Appn. No. 10/791,701
Amdt. dated June 22, 2005
Reply to Office Action of February 22, 2005

Amendments to the Drawings

ANNOTATED DRAWING SHEET SHOWING CHANGES

FIG. 1

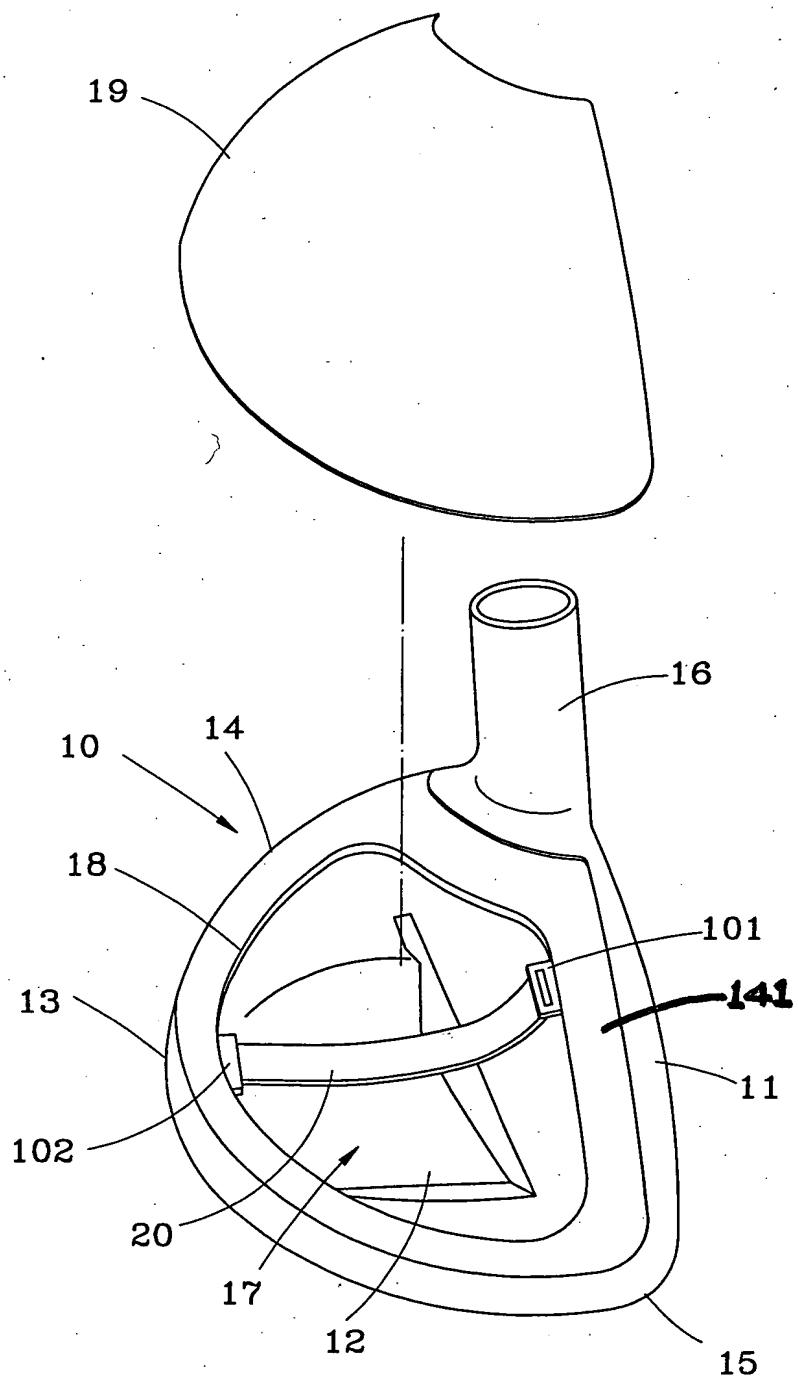
The attached sheets of drawings includes changes to Fig. 1 and Fig. 2. These sheets, which include Fig. 1 - 3, replaces the original sheets including Figs. 1-3. In Figs. 1 and 2, previously omitted element 141 has been added. Fig. 3 is unchanged.

Applicant has enclosed herewith amended Figs. 1 and 2, identifying the upper portion 141 of the crown portion 14, and has amended the specification to include upper portion 141. No new matter has been added.
